Report: TAB REPORT
Function: Test, Adjust, & Balance
Date: 11/19/2025
Completed By: National TAB

11-17-25 CHIPOTLE #5765 NOLENSVILLE, TN

Project Issue Information

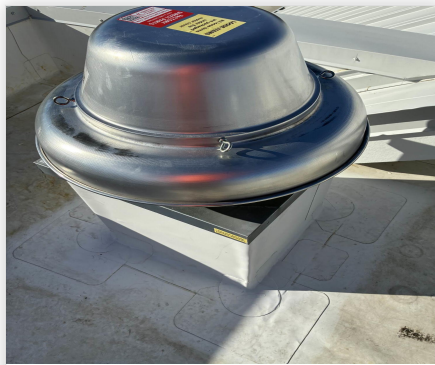
Issue Name : EF-2 GRILLS
Description : EF-2's exhaust grills are different from what design calls for. This did not impede TAB; dampers were present on ductwork.
Created By : National TAB **Assigned To :** National TAB - Noah Stafford
Status : Open
Priority : Low **Asset Tag :** EF2
Originated Date : 11/18/2025 - Noah Stafford - National TAB
